ADDENDUM NO. 01

RANKIN TRAILS AMPHITHEATER AND BASEBALL PARK

Rankin County, Mississippi

WBA Proj. # 2215/2315

ADD1-E1

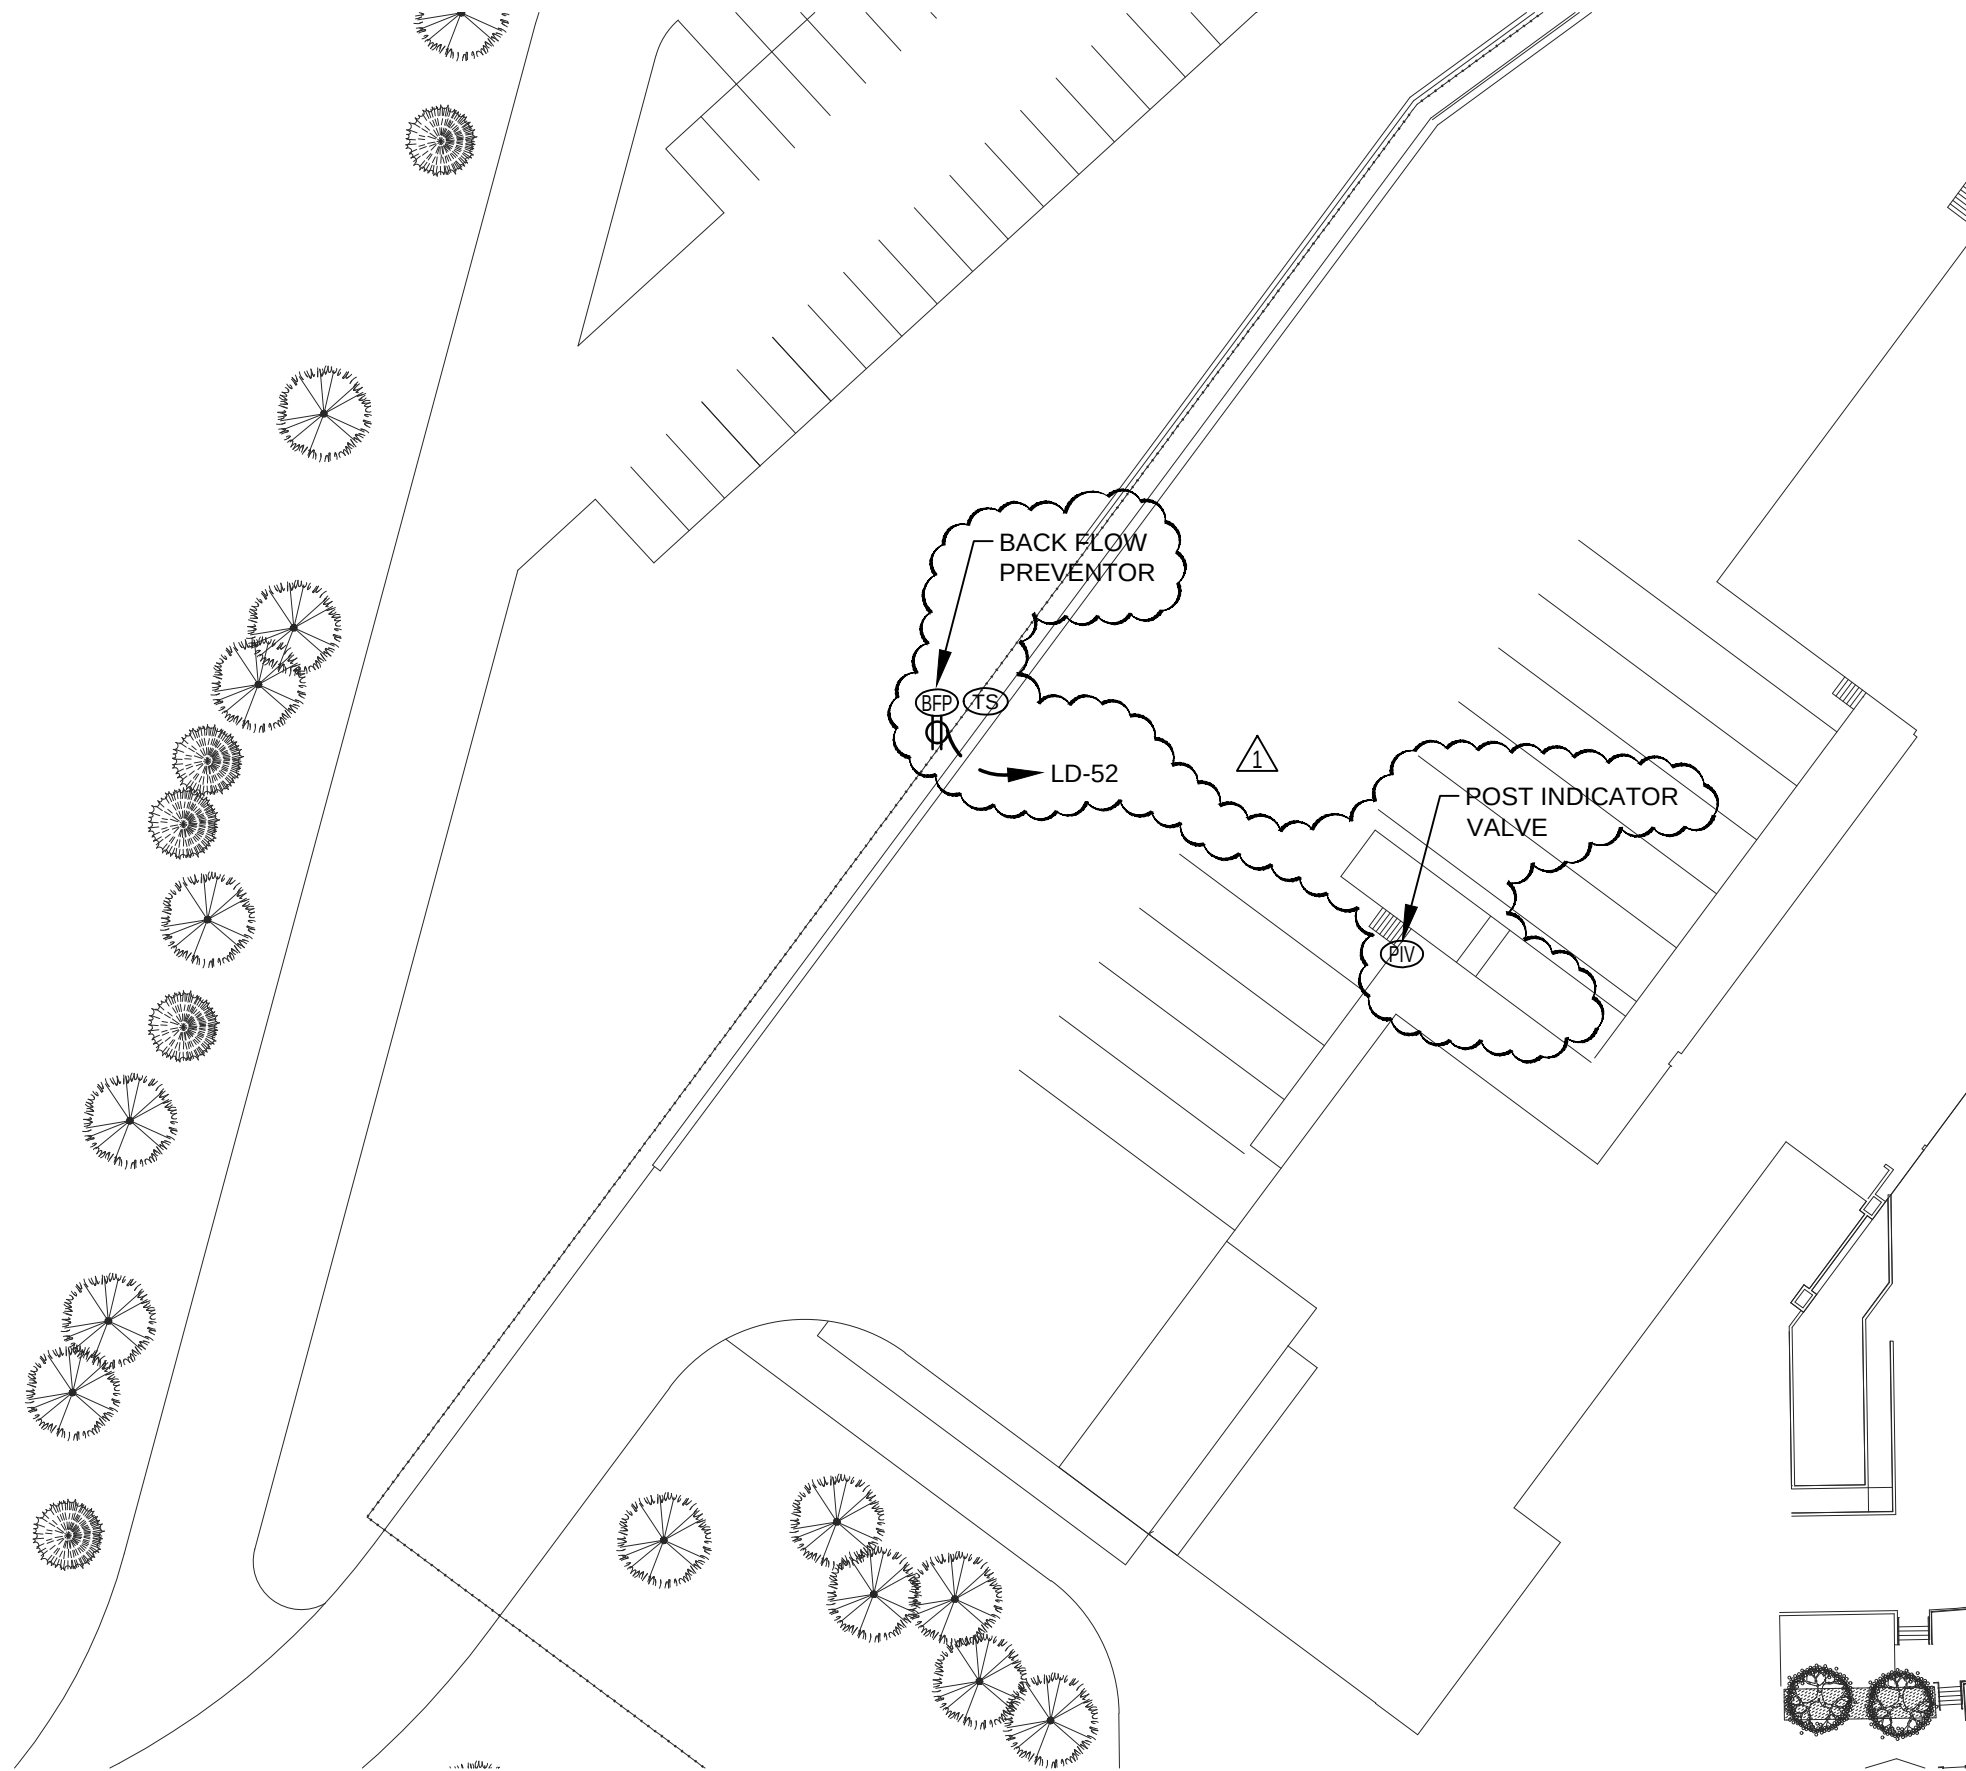
- ITEM NO. 24** **SHEET E1.00 ELECTRICAL LEGEND**
REVISE per enclosed sheet ADD1-E1.
- ITEM NO. 25** **SHEET E1.07 ELECTRICAL SITE PLAN**
REVISE per enclosed sheet ADD1-E2.
